Item No.
1

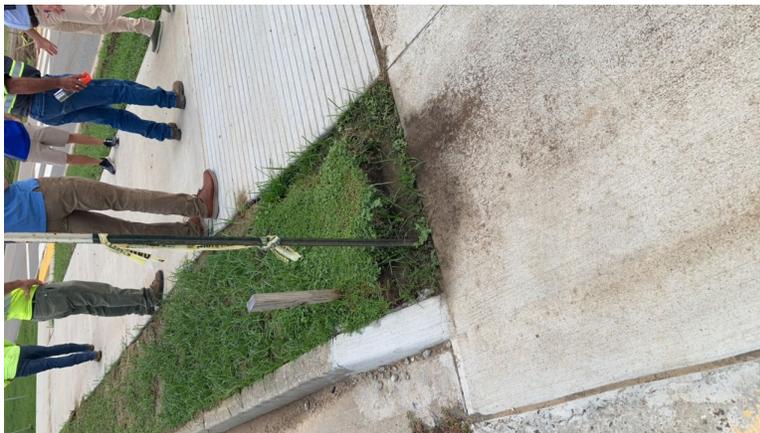
Description
Remarks:
Replace parking bumper - \$100
X: 30.093313
Y: -92.003082
Collection Date:
2024-07-25
15:03:51

Item No.
8

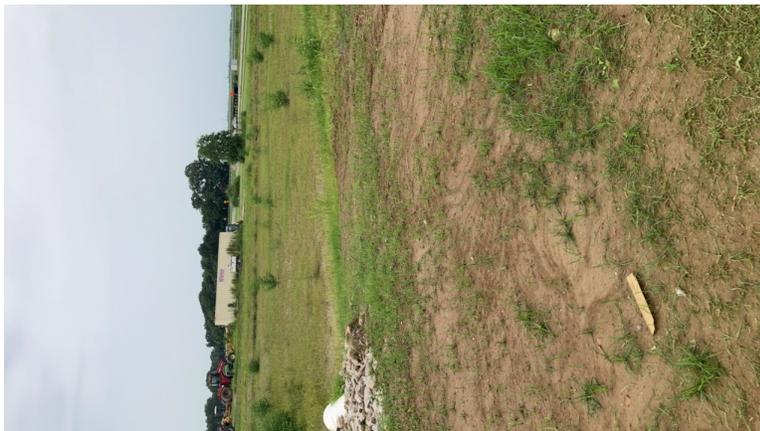
Description
Remarks:
Remove debris
from site
X: 30.092724
Y: -92.004074
Collection Date:
2024-07-25
15:18:27

Item No.
12

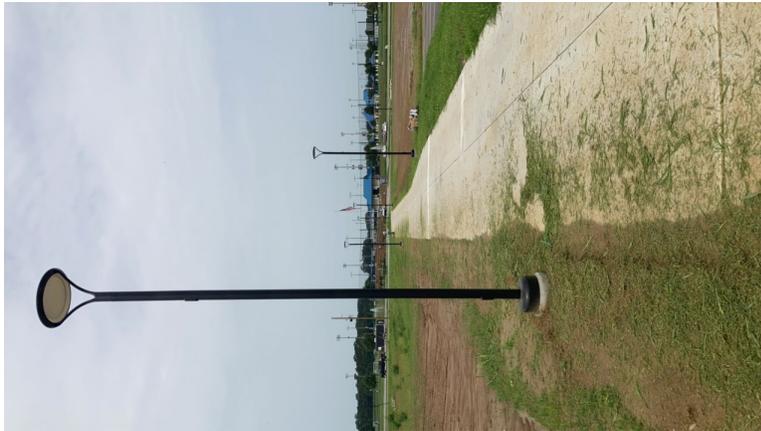
Description
Remarks:
Remove debris
from site
X: 30.092783
Y: -92.003662
Collection Date:
2024-07-25
15:22:16

Item No.
14

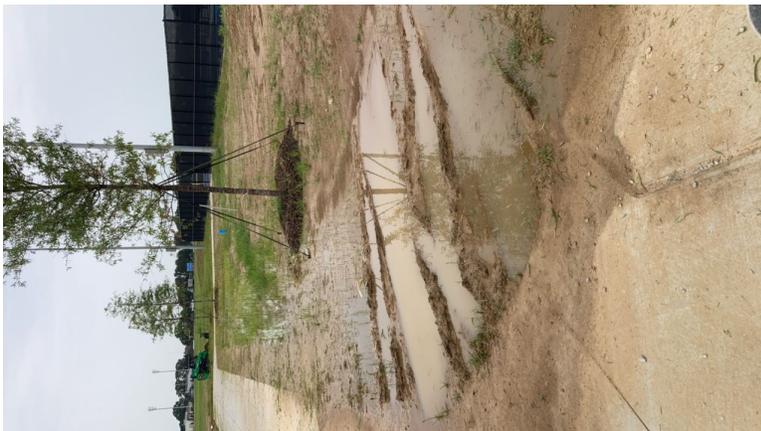
Description
Remarks:
Install drain box and pipe, sod area near sidewalk intersection
X: 30.092802
Y: -92.002892
Collection Date:
2024-07-25
15:28:50

Item No.
24

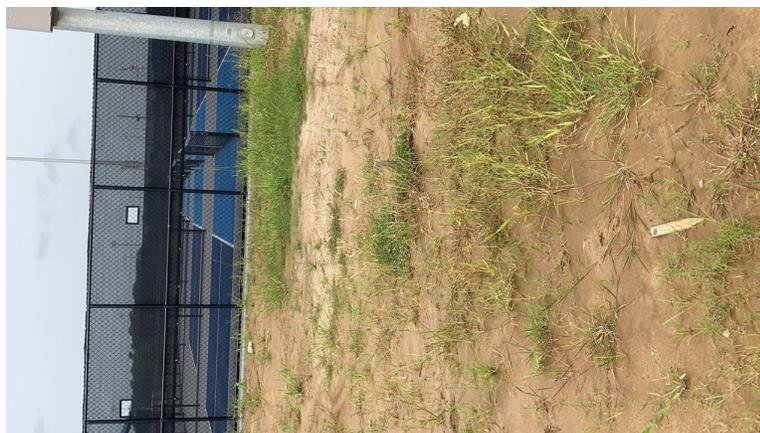
Description
Remarks:
Replace gate
latch
X: 30.092398
Y: -92.003342
Collection Date:
2024-07-25
15:49:53

26

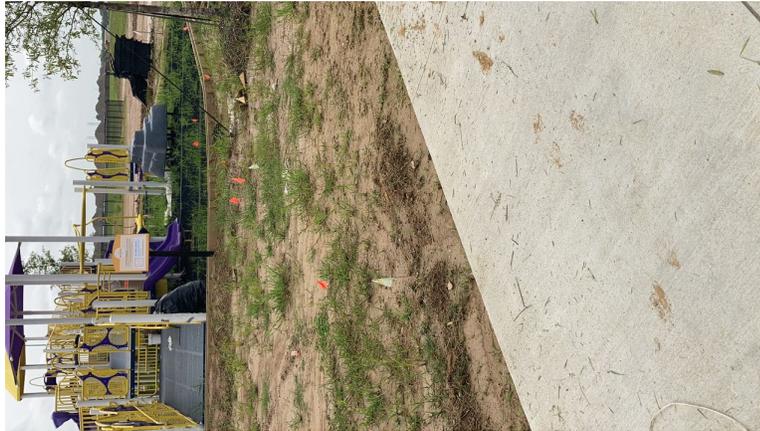
Remarks:
Install concrete
access to
playground
X: 30.092669
Y: -92.002853
Collection Date:
2024-07-25
15:55:33.000001

Item No.
55

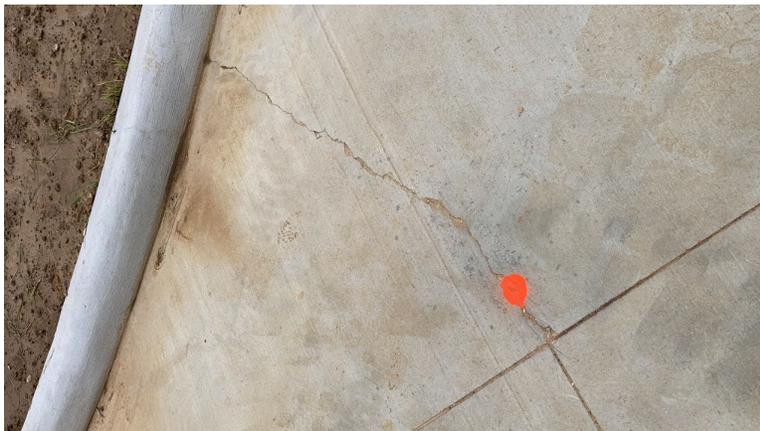
Description
Remarks:
Remove and
replace low
concrete; patch
lifting eye
X: 30.093439
Y: -91.999863
Collection Date:
2024-07-25
17:38:01

Item No.
57

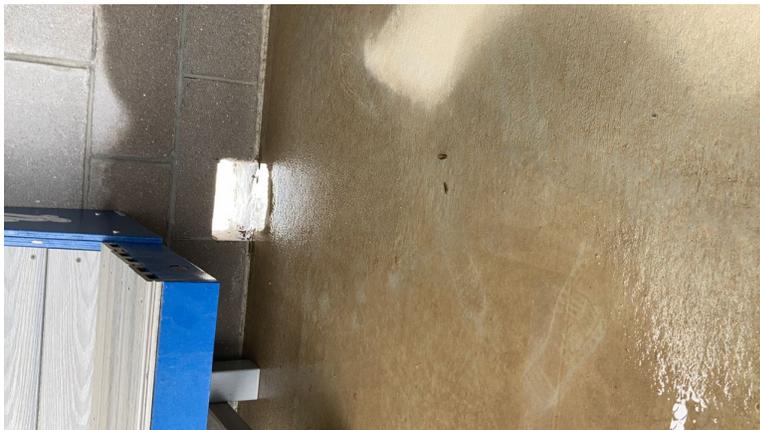
Description
Remarks:
Monitor cracks.
X: 30.093477
Y: -92.000603
Collection Date:
2024-07-25
17:46:39

62

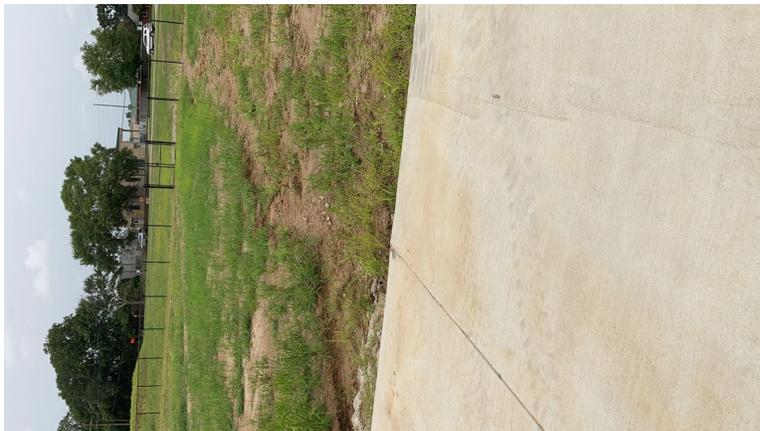
Remarks:
Redress area
X: 30.093889
Y: -92.001297
Collection Date:
2024-07-25
17:58:10

Item No.
64

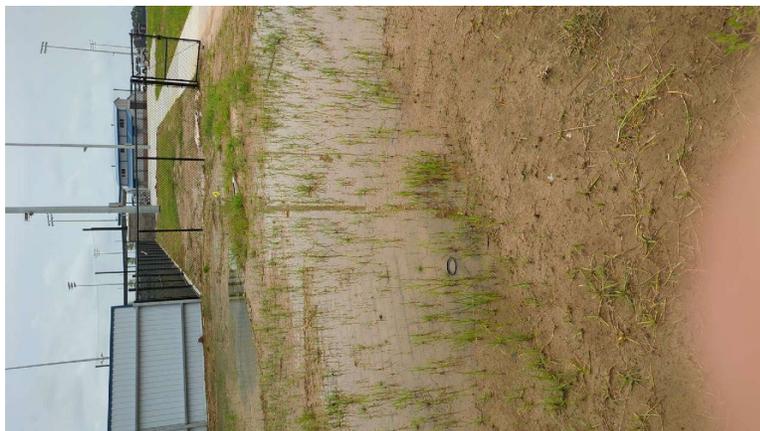
Description
Remarks:
Slope area to CB
behind fence.
X: 30.094324
Y: -92.001602
Collection Date:
2024-07-25
18:00:04.000001
